Osprey 2
Modification to Hull
addition of 4" forward of step
Dwg #2A

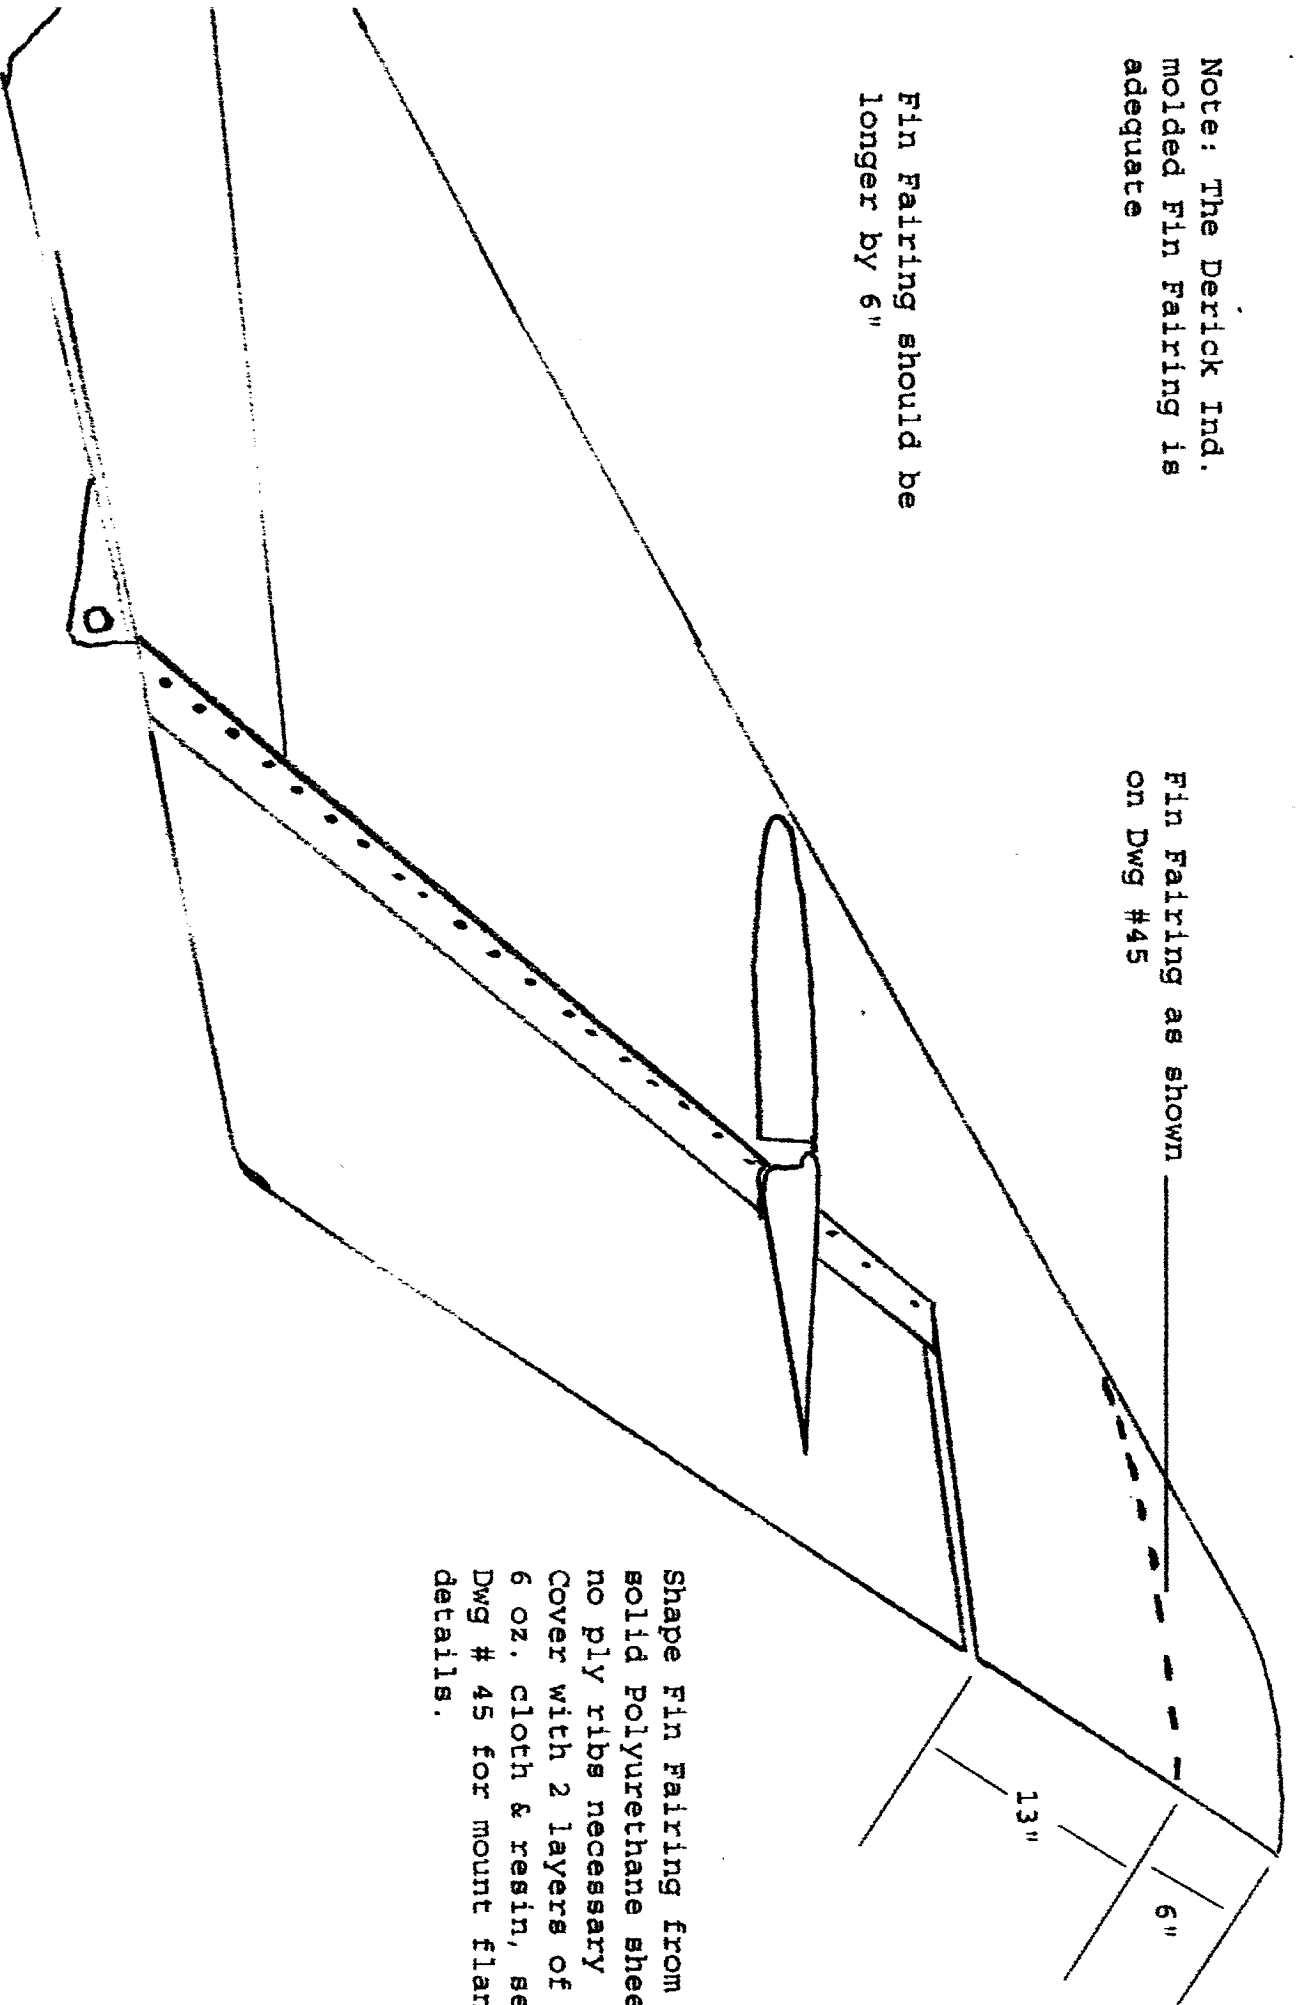
Fin Fairling should be
longer by 6"

Shape Fin Fairling from
solid Polyurethane sheet
no ply ribs necessary
Cover with 2 layers of
6 oz. cloth & resin, see
Dwg # 45 for mount flange
details.
